Value Engineering Study Report

Project No. HPP00-0000-00(345)

*SR 307 – New Overpass over Port Authority Rail Line
Chatham County*

RE: Submittal of the final Value Engineering Report
Project No.: HPP00-0000-00(345)
P.I. No.: 0000345
SR 307 – New Overpass Over Port Authority Rail Line
Chatham County

ALTERNATIVE NO.:
RD-3

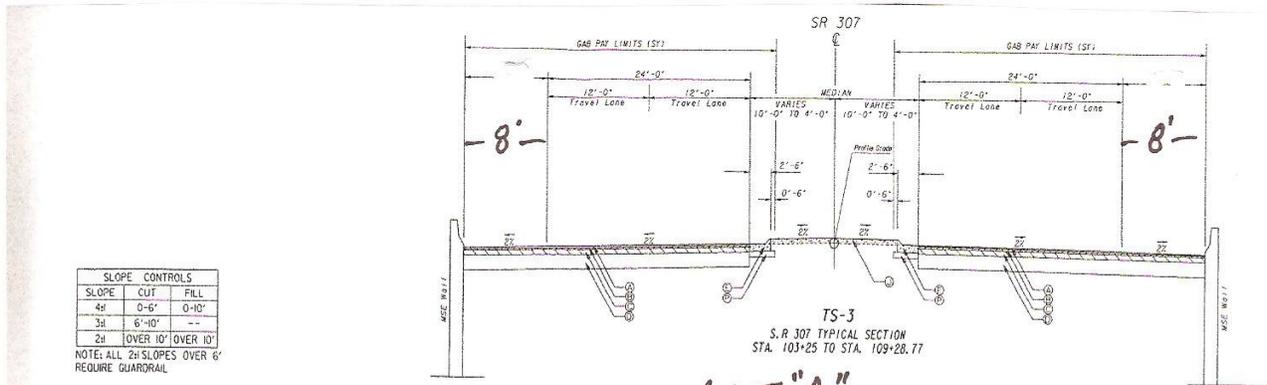
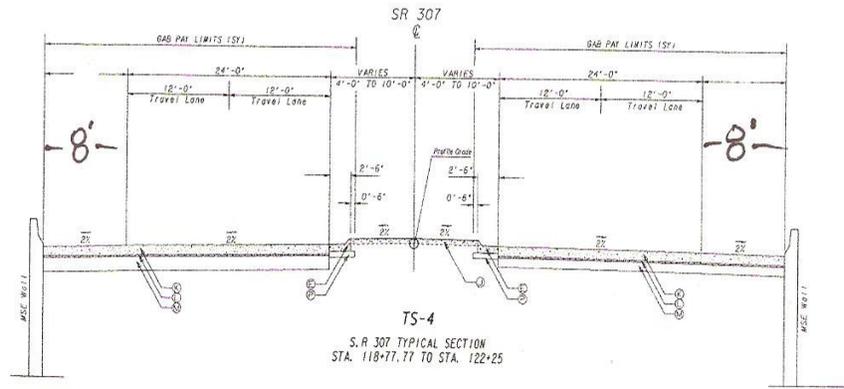
The original design calls for a 10' outside shoulder on bridge approach areas contained by the MSE walls from STA 103+25 to STA 109+29 and from STA 118+78 to STA 122+40.

The alternative proposes narrowing the 10' paved shoulder to an 8' paved shoulder in the areas described above.

The intent of the alternative is to narrow the outside shoulders on both approaches to the bridge which are bound by an MSE wall. This alternative may be used in conjunction with Alternative BR-2, which proposes narrowing the outside shoulders on the bridge to an 8' width. The project as designed has 8' shoulders, of which only 6'-6" is paved from STA 93+85 to STA 103+25. The result of narrowing the 10' full depth paved shoulder to 8" would result in flexible and PCC pavement savings, GAB savings, and would narrow the footprint required to construct the bridge approaches. This would also save on earthwork costs by narrowing the area bound by the MSE wall.

ALT. "A"
 REDUCE WIDTH OF OUTSIDE SHOULDERS TO 8'
 WEST OF BRIDGE APPROACH IN PROPOSED ASPHALT SECTION.

ALT. "B"
 REDUCE WIDTH OF OUTSIDE SHOULDERS TO 8' EAST
 OF BRIDGE APPROACH IN PROPOSED P.C.C. SECTION.

ALTERNATIVE NO.:
RD-4

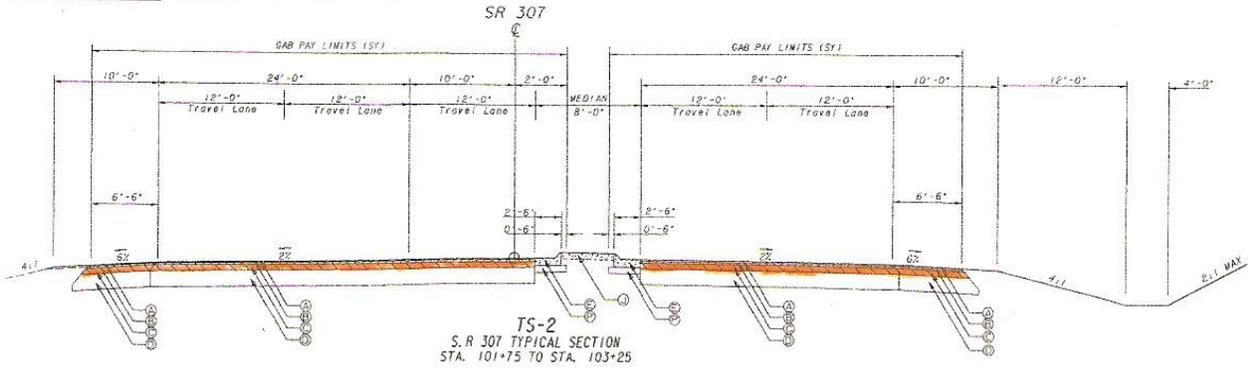
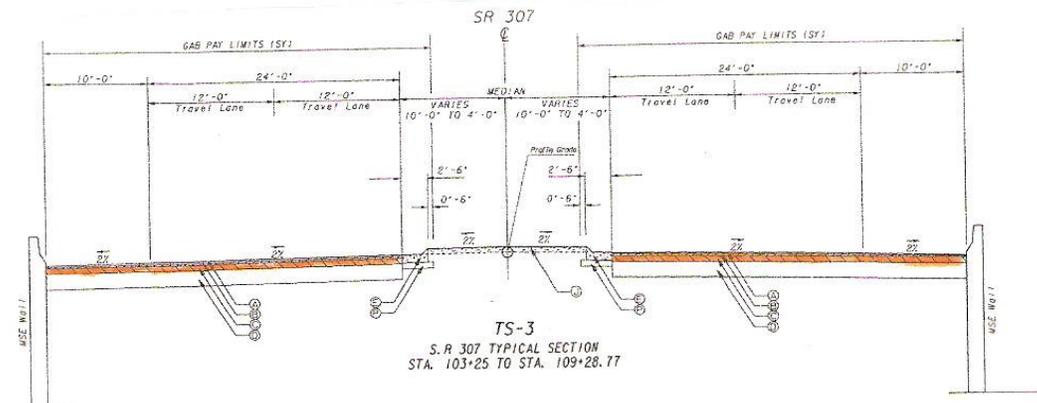
The original design calls for constructing the western portion of the project from the west approach slab at STA 109+00 to the beginning of the full build-up section at STA 101+75 of flexible pavement with a 16" GAB base.

The alternative proposes to use PCC to construct the western portion of the project from STA 109+00 to STA 101+75.

The alternative proposes constructing the western portion of the project with PCC instead of the asphalt build-up proposed in the original design. The limits for the alternative proposal range from the west end of the bridge end slab at STA 109+00+/- to STA 101+75. The alternative separates the proposed PCC pavement into two sections, Section I from STA 109+00+/- to STA 103+25 contains 10' outside shoulders, and is in the approach area to the bridge bound by the MSE wall to the north and south. Section II begins at STA 103+25 and goes to STA 101+75. Section II is outside of the bridge approach areas and has 6'-6" paved shoulders. STA 101+75 to the western end of the project at STA 93+85 were excluded from this alternative, as that section is an overlay only. The construction of all full build-up areas on the project with PCC would be desirable considering the volume and concentration of truck traffic. Construction with PCC on this project will reduce staging issues with future planned projects to the west of the existing project limits. A cost estimate is attached with this alternative, as well as a life cycle cost analysis. The life cycle cost analysis shows significant savings over the material life span.

-DELETE FLEXIBLE PAVEMENTS IN SECTIONS I+II;
G.A.B. QUANTITIES REMAIN THE SAME. REPLACE
PROPOSED FLEXIBLE PAVEMENTS WITH P.C.C.

ALTERNATIVE NO.:
D-2

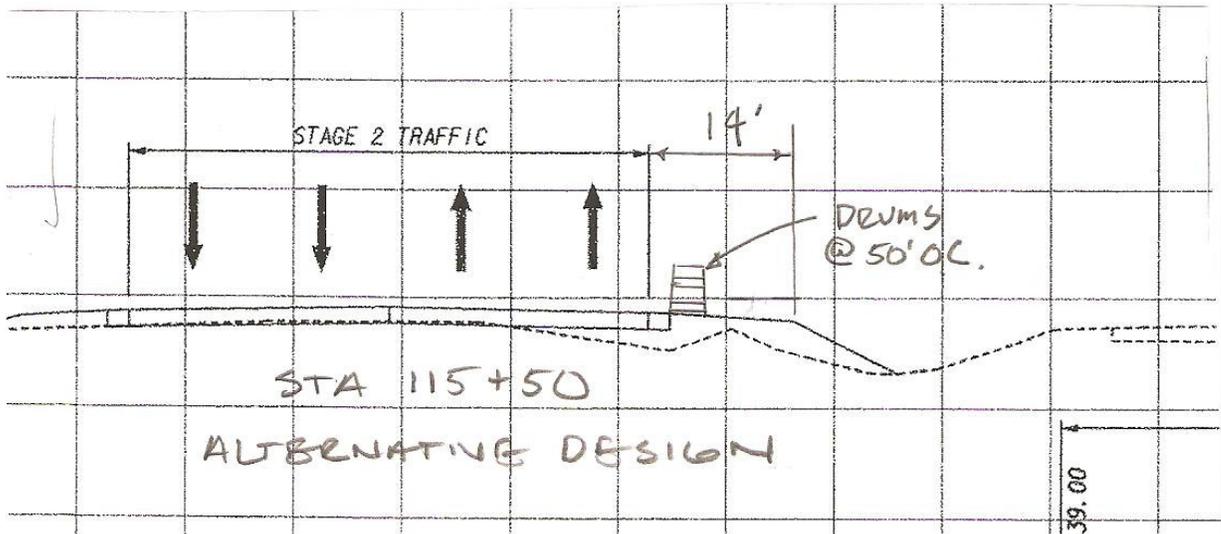
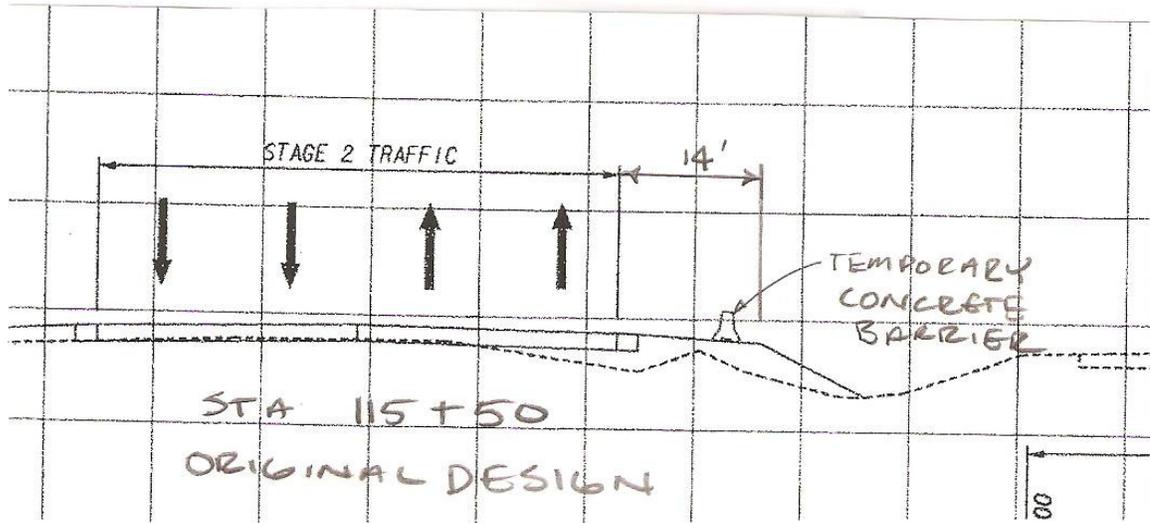
The original design provided a concrete safety barrier at the edge of a 10' graded shoulder with an additional offset behind the barrier (varies 25' to 60') for the contractor to construct the project.

The alternative would provide a 14' clear zone at a minimum 6:1 side slope (Design Speed \leq 40 mph & ADT > 6000 vpd) in accordance with the requirements of the AASHTO 2006 Roadside Design Guide, eliminate the use of temporary concrete barrier and the corresponding impact attenuators and utilize construction drums to delineate the work zone.

Temporary barrier located on a graded shoulder will pond water on the shoulder resulting in damage and creating a maintenance problem. Flood waters frequently overtop this section of roadway and the barrier will serve as a "dam" causing an increase in negative flooding impacts in the designated floodplain. While providing a positive barrier can increase worker safety, since the posted speed of the detour will be 35 mph any benefits would be minimal. Removing the barrier will improve the contractor's access to the work and should speed construction. The original design already requires a graded area of 14' at a 6% grade from the edge of the through lane so no additional grading will be required.

ALTERNATIVE NO.:
D-3

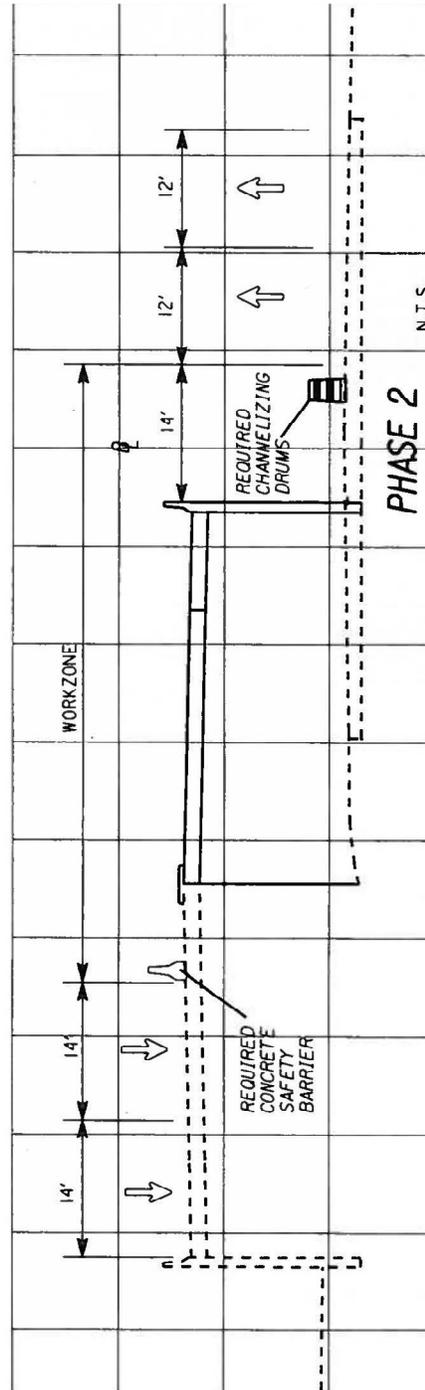
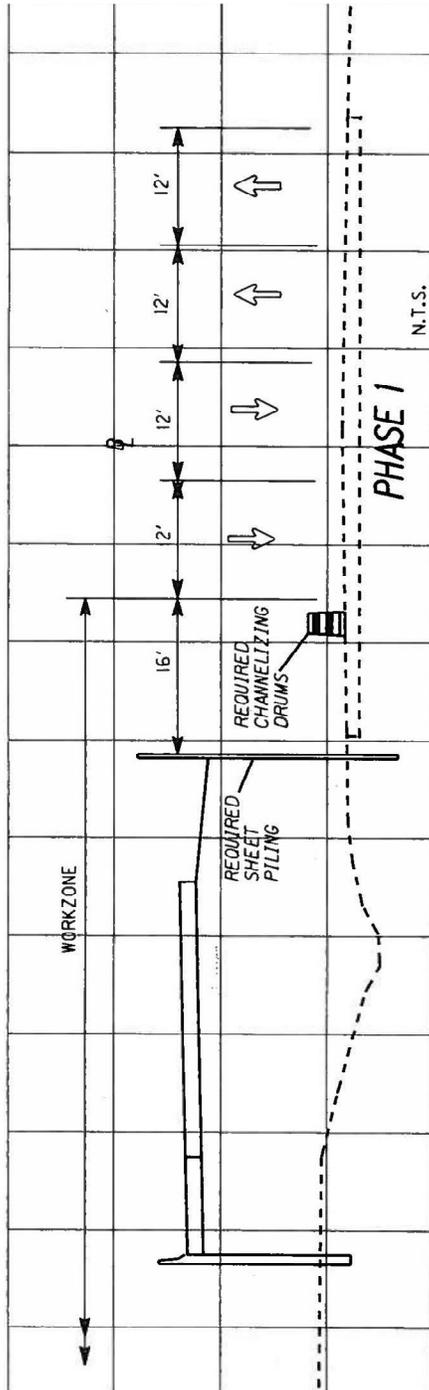
The original design proposes utilizing a temporary detour to the north of the existing roadway. This detour will be built on a temporary construction easement and removed after use.

Construct the permanent roadway to the north of the existing roadway and phase the construction half at a time in order to reduce the required permanent right of way and reduce the curvature introduced into the final alignment.

By constructing the permanent roadway slightly offset to the north of the existing roadway and constructing it in phases it will eliminate the need for constructing an offsite detour. This will not only eliminate the need for the temporary paving but also the temporary drainage and the temporary railroad crossing. This will also reduce the exposure to rail traffic by putting half the traffic on the grade separation earlier.

ALTERNATIVE NO.:
BR-1

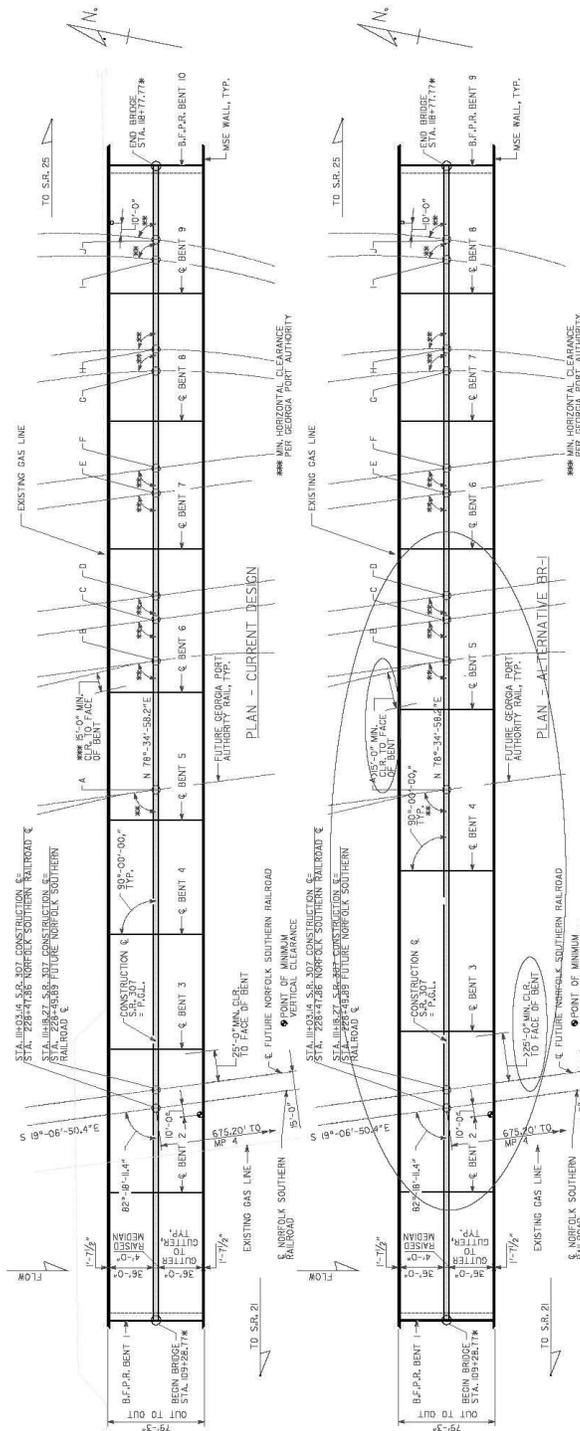
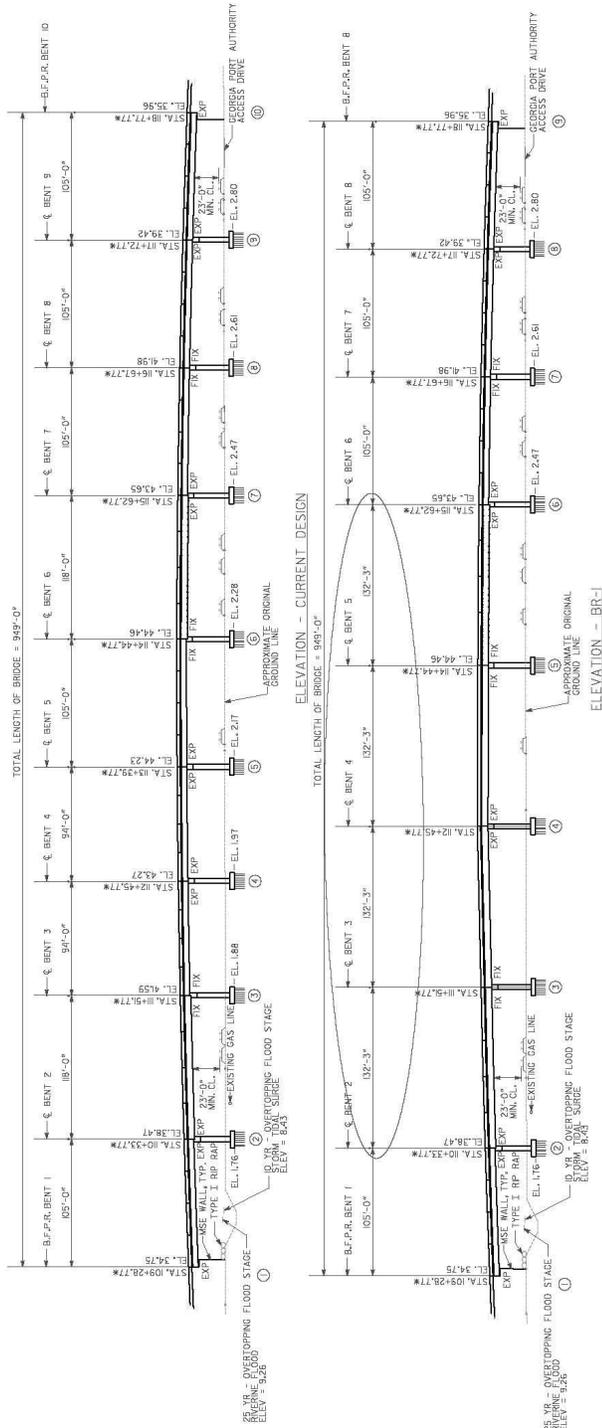
The original design calls for a 949' long, 9 span bridge with wrap-around MSE walled abutments. The spans are of lengths 94' & 105' with BT 54 PPC girders and 118' with BT 63 girders. The out-to-out width of the bridge is 79'-3" to accommodate 10' foot shoulders on each side, an 8' median (4' raised) and two 12' travel lanes in each direction. The intermediate bents are made up of concrete caps and columns and founded on PPC piles supporting a pile cap. Span 1 crosses a canal while spans 2, 5, 6, 7, 8 & 9 cross railroad tracks and a Georgia Port Authority access drive.

The alternative suggests optimization of the span arrangement. Five intermediate spans, 2, 3, 4, 5 & 6 can be rearranged to accommodate four 132'-3" spans and elimination of one intermediate bent. All other geometry remains the same as in the original design.

The rearrangement of spans offers the opportunity to eliminate one intermediate bent. BT 63 girders can be used on the 132'-3" spans with no effect on the existing vertical clearance. Higher strength concrete may be used if required. Larger number of similar sized girders could result in potential savings in fabrication and mobilization costs while at the same time speeding up installation and construction.

ALTERNATIVE NO.:
BR-2

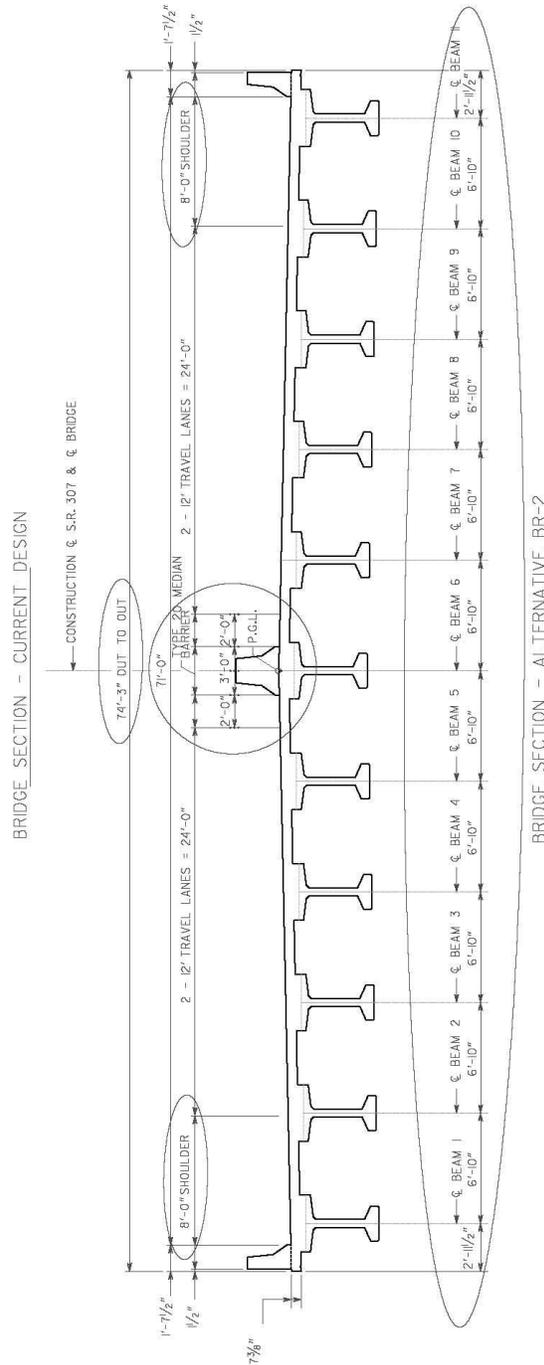
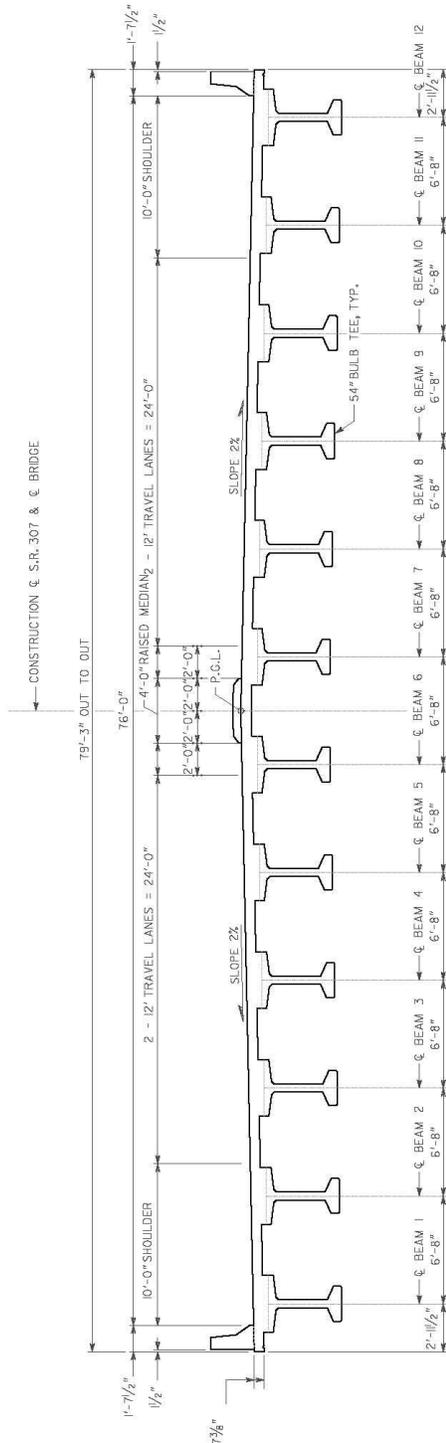
An intermediate concrete barrier, 3' wide at the bottom with 2' buffers on either side, in-lieu of the 4' raised median, will provide positive traffic separation.

ALTERNATIVE NO.:
BR-8

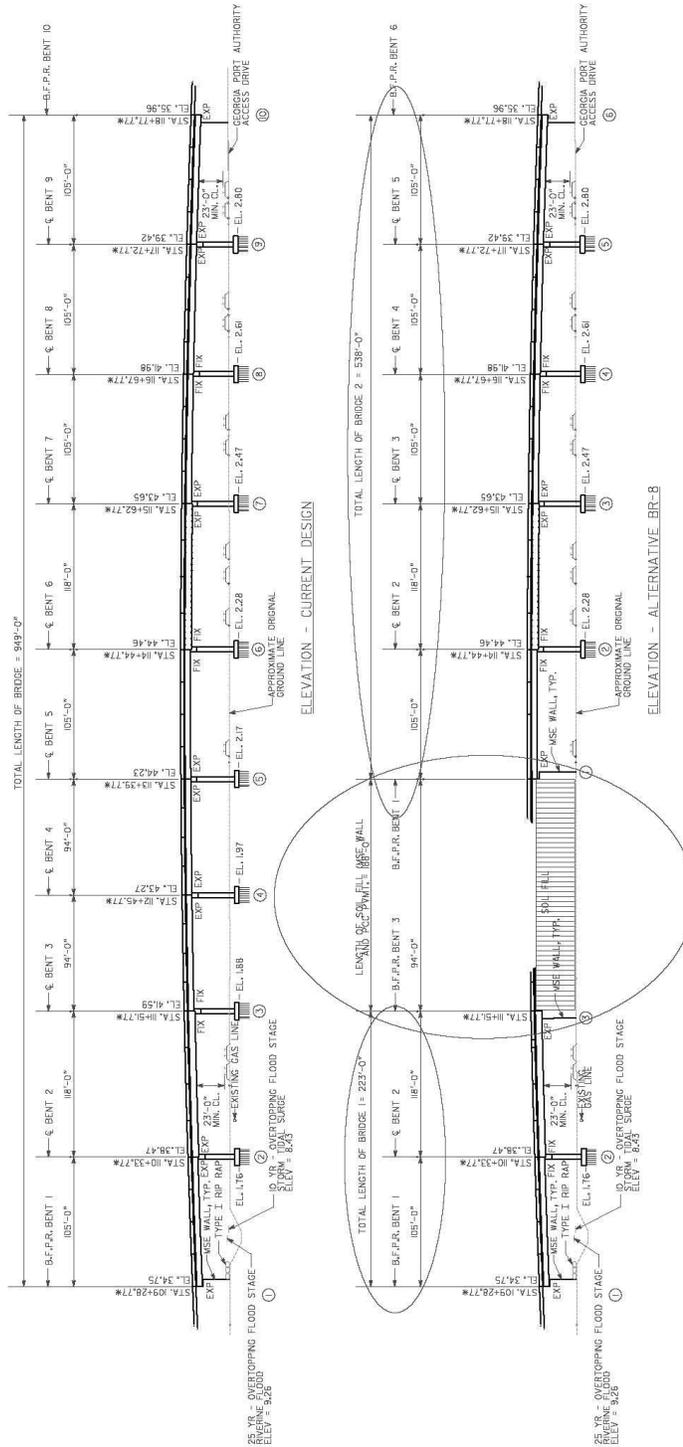
DESCRIPTION: **Replace spans 3 & 4 with fill**
